#### ADDENDUM NO. 7

**June 6, 2022**

# LIBERTY INTERMEDIATE SCHOOL ADDITIONS AND RENOVATIONS

This Addendum consists of Pages ADD 7-1 through ADD 7-4 and attached Addendum No. 7 from Gibraltar Design dated June 6, 2022 and consisting of 5 pages and 75 drawings.

GIBRALTAR DESIGN SHEET MD101

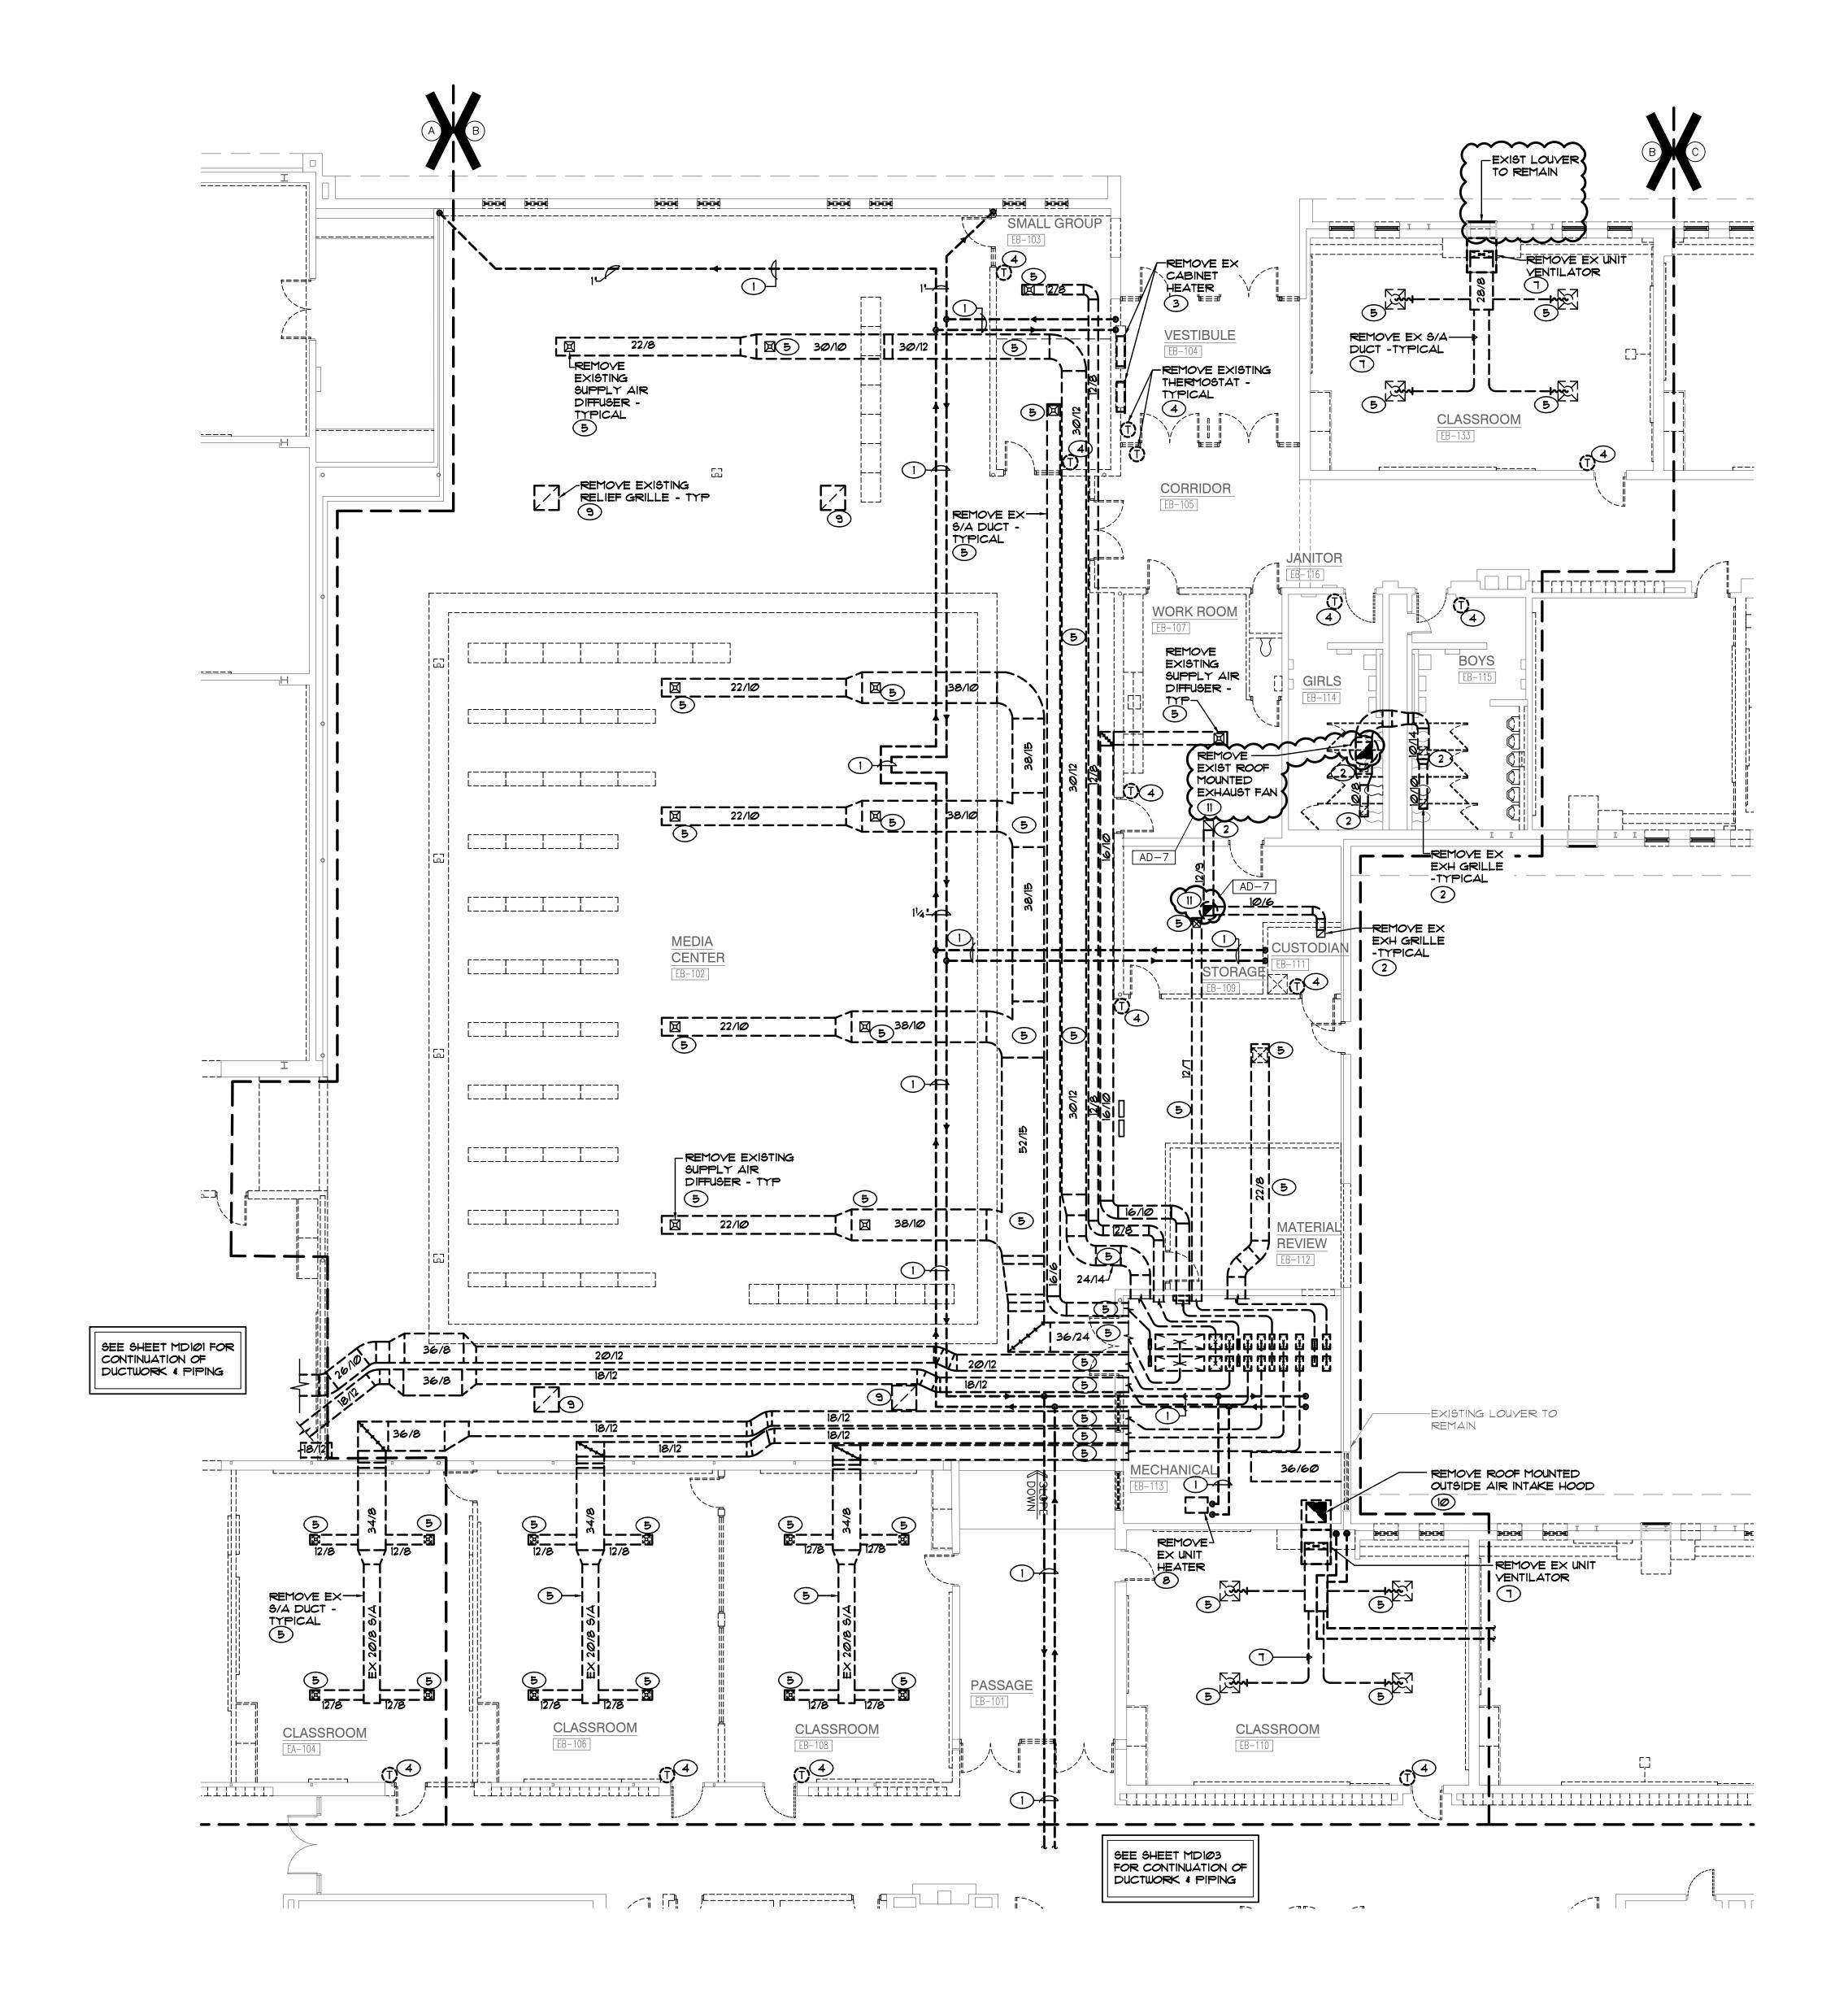
- A. Refer to revised full-size drawing included in this Addendum, for the following revisions:
  - 1. Added demo exhaust fans.
  - 2. Added sheet note 9.

MD102

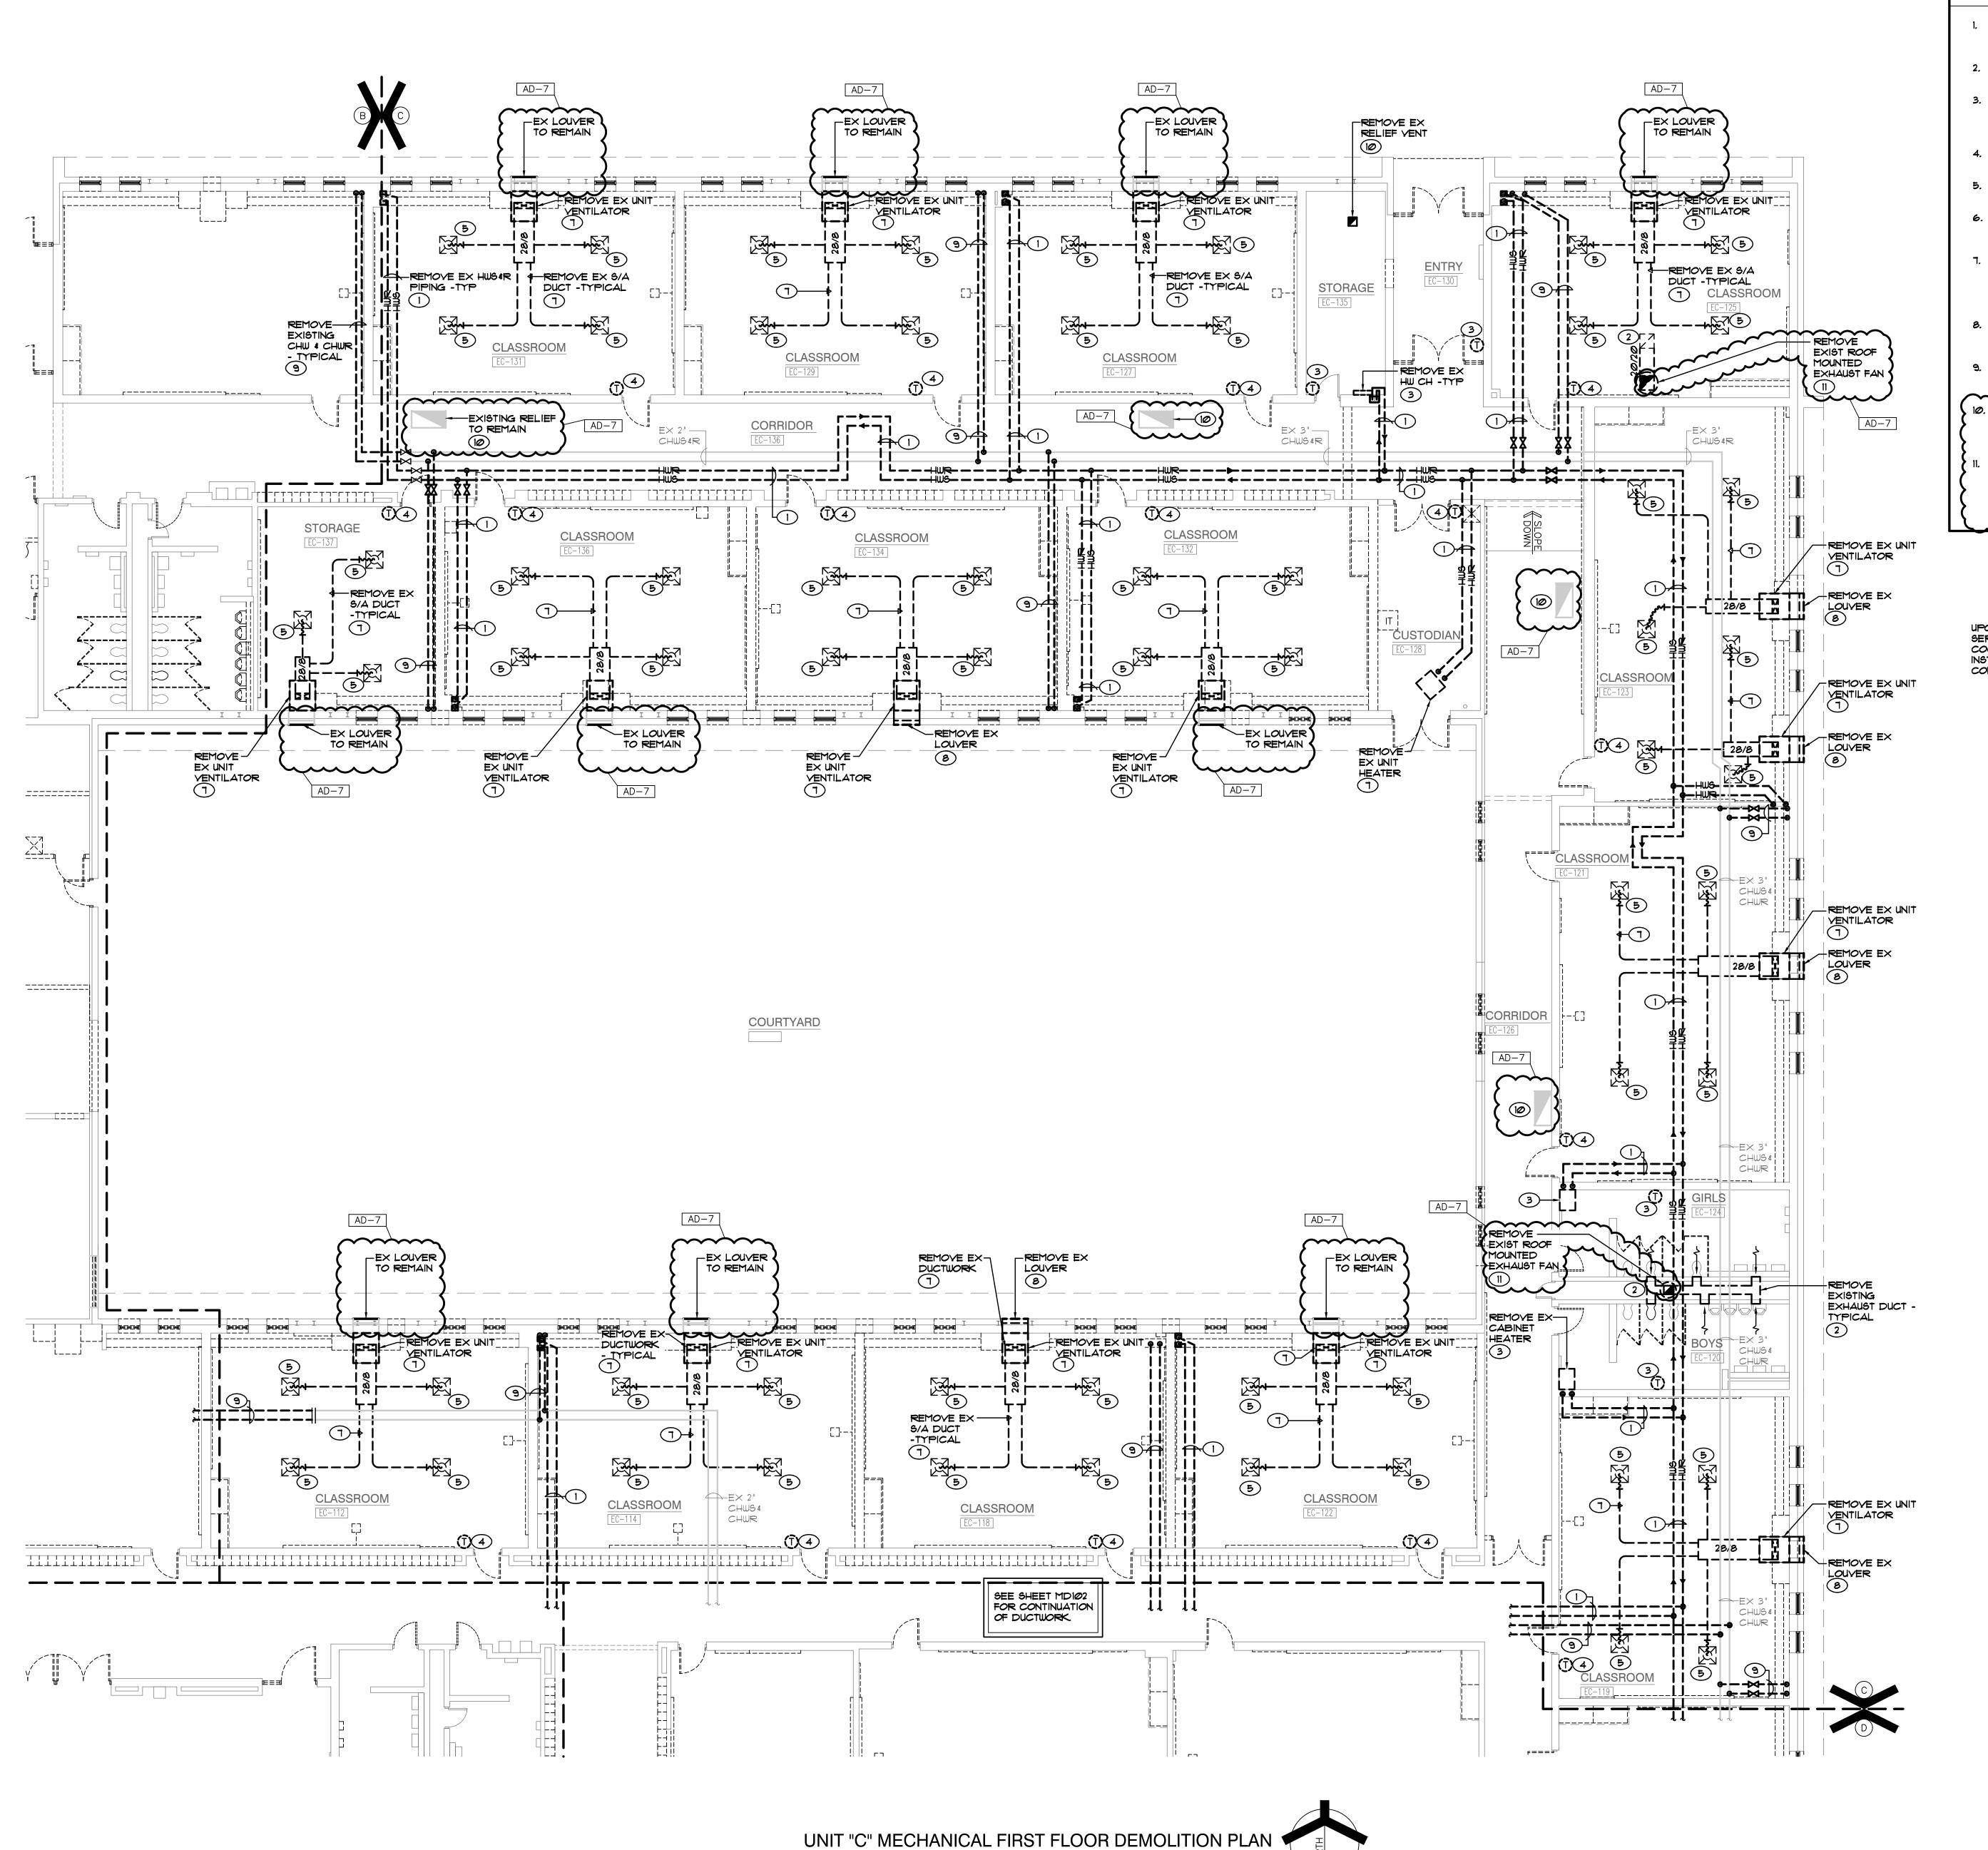
- A. Refer to revised full-size drawing included in this Addendum, for the following revisions:
  - 1. Added demo exhaust fans.
  - 2. Added sheet note 11.

MD103

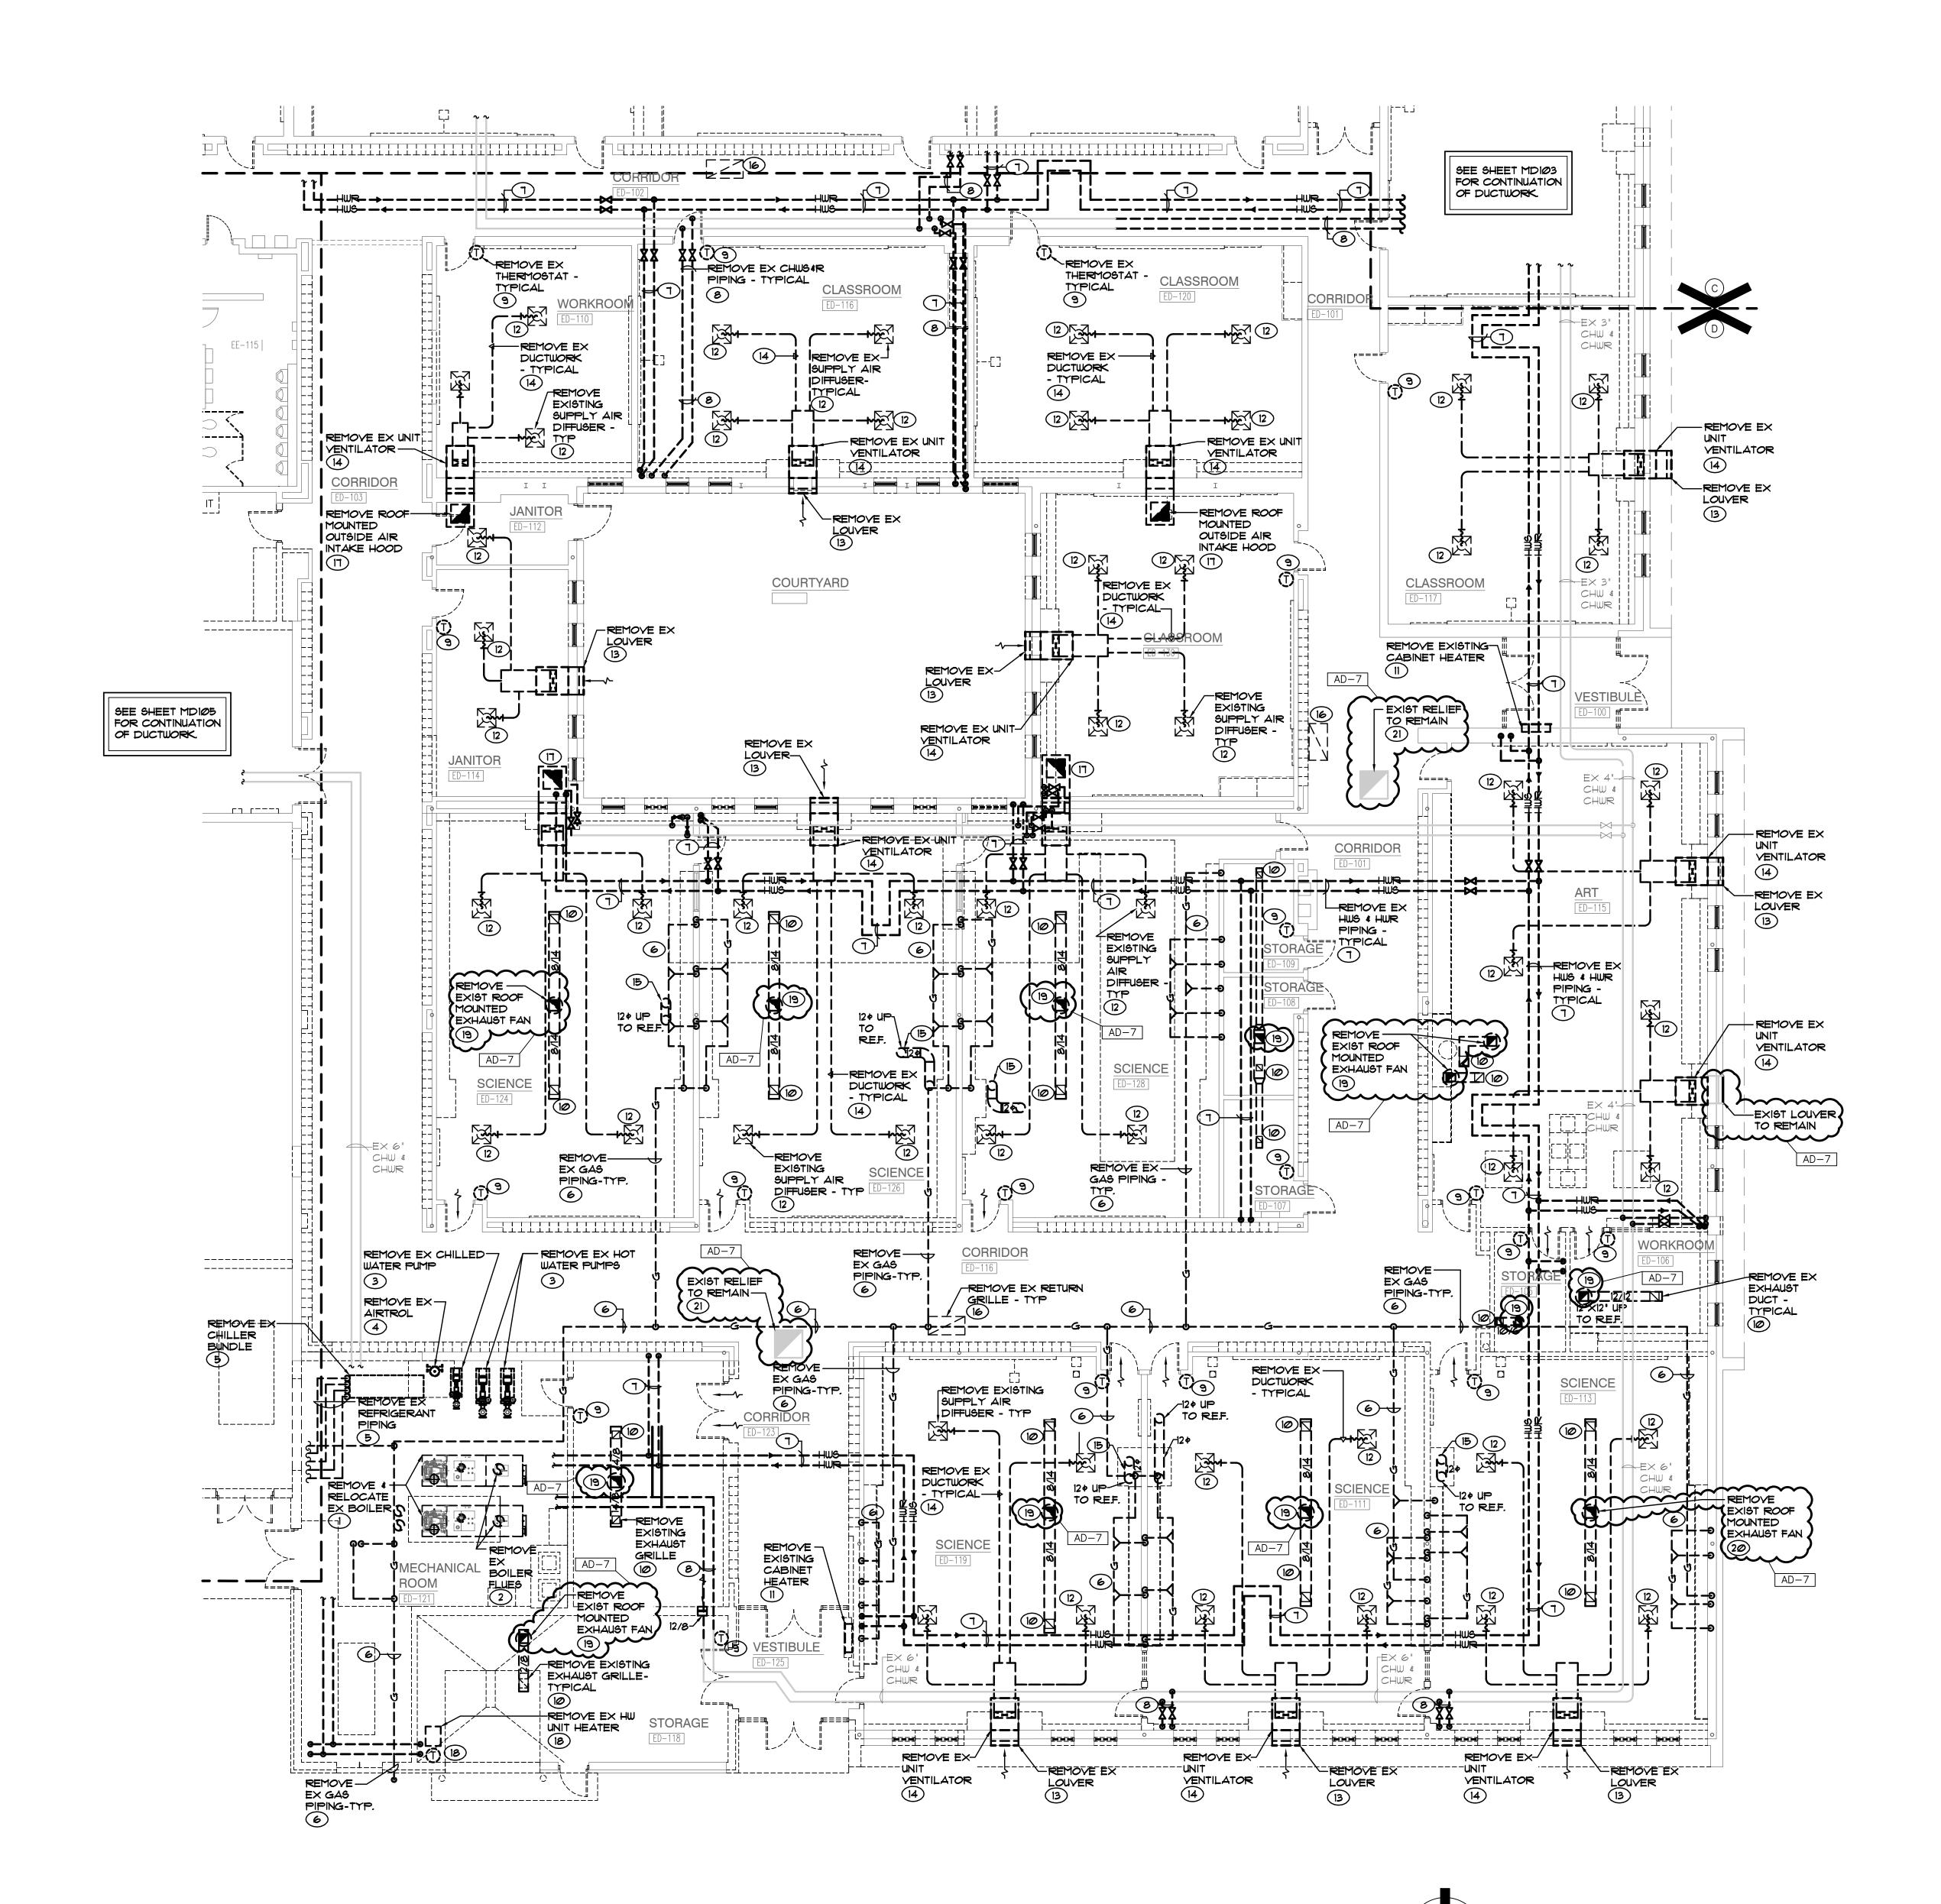
- A. Refer to revised full-size drawing included in this Addendum, for the following revisions:
  - 1. Added demo exhaust fans.
  - 2. Added sheet note 11.
  - 3. Revised sheet note 10.
  - 4. Revised demo relief to existing to remain.
  - 5. Revised louver from demo to existing to remain.
